Technical Bulletin

TB0354 – 3 Feeder RMUs in 22kV Areas

Date: 03/09/2024

Figure 1: Typical illustration for 'switching station' in 22kV areas

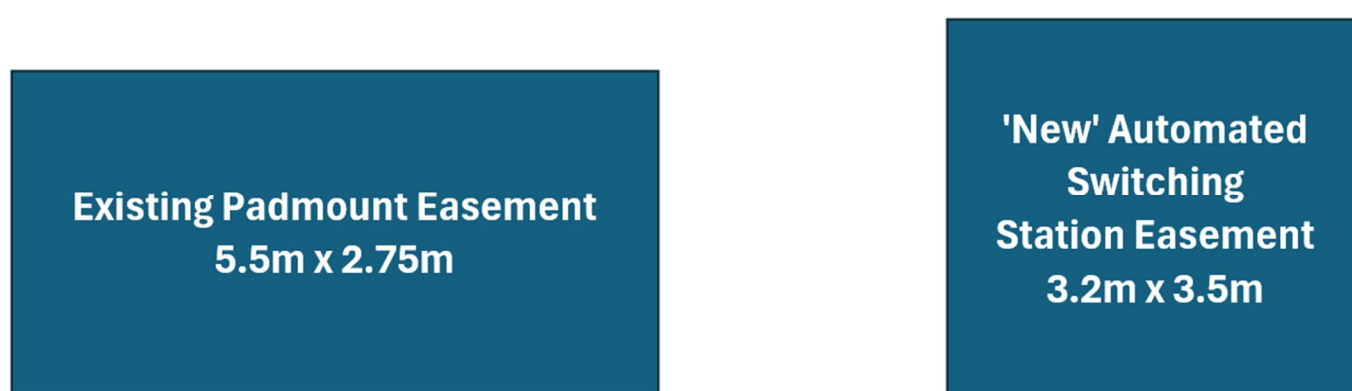
- Where the Method of Supply identifies a need for a '**manual**' 3 feeder (with fuse switch) RMUs in 22kV areas – we **may** impose a switching station in addition to the padmount substation for this development.
- Where the Method of Supply identifies a need for an '**automated**' 3 feeder (with fuse switch) RMUs in 22kV areas – we **will** impose a switching station in addition to the padmount substation for this development. Refer Figure 1 below.

Noting that these switching station easements for the automated scenario will be required to be 3.2m x 3.5m to accommodate automation equipment and available switchgear (not the traditional 2.75m x 2.75m).
